U.S. NUCLEAR REGULATORY COMMISSION
OFFICE OF INSPECTION AND ENFORCEMENT

IE Bulletin No. 78-05

**MALFUNCTIONING OF CIRCUIT BREAKER AUXILIARY CONTACT MECHANISM -
GENERAL ELECTRIC MODEL CR105X**

**FIGURE 1
REMOVING OVERLOAD RELAY MOUNTING BRACKET**

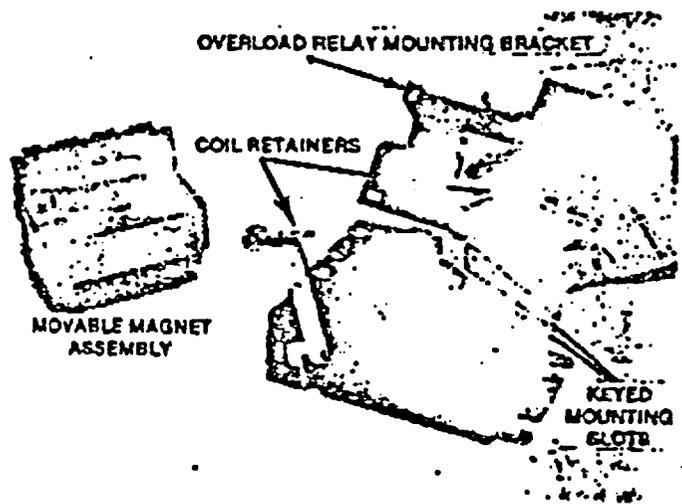
REMOVING OVERLOAD RELAY BRACKET (SEE FIG. 1)

1. Remove all electrical power from device.
2. Disassemble device by pressing on the coil while pulling out on the coil retainers. Move retainers back and away from coil.
3. Grasp movable portion of magnet and pull out, removing magnet assembly, coil, molded cover and movable arm in one motion. (NOTE: On reversers or multispeed starters, this magnet assembly is linked to the mechanical interlock arm between contactors and should be tipped toward interlock arm to facilitate easy removal.)
4. Remove overload relay bracket by sliding it out of the keyed slots in the molded base. (NOTE: If any wires are too short to allow easy removal, temporarily disconnect these.)
5. Remove overload relay from bracket by loosening screw on bottom of overload bracket.

FIGURE 2

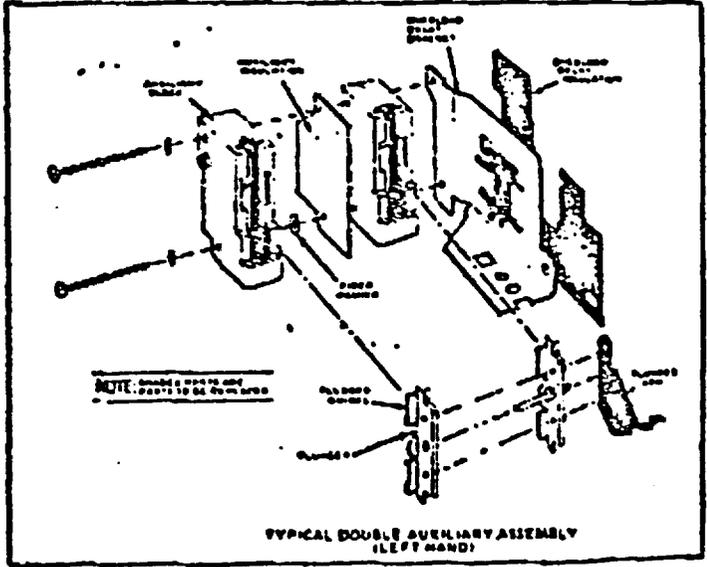
CHANGING PLUNGER ARM & INSULATION (SEE FIG. 2)

1. Slide plunger assembly out of auxiliary contact block, by lifting up and out.
2. Select the new plunger arm that is bent the same way as the one installed.

3. Loosen screw on plunger to release metal arm but **DO NOT REMOVE SCREW FROM PHENOLIC PLUNGER (OR PLUNGERS)**.
4. Mount new plunger arm on plunger. Fasten arm to plunger with screw (or plunger post if installing double aux blocks).

5. Apply thin coat of aeroshell grease along plunger guides.
6. Reinstall plunger assembly in contact block.
7. Reassemble overload to mounting bracket. Remove overload insulation and install new. (NOTE: Overload insulation must be removed and replaced with new insulation supplied with kit.)

8. Remount complete assembly on contactor base.
9. Reconnect any wires previously removed.
10. Reassemble magnet assembly to contact base (on reversers or multispeeds be sure to interlock this assembly with mechanical interlock arm. Check for free movement of armature assemblies and mechanical interlocks).

11. Observe that auxiliary contact plunger assemblies are operating properly.
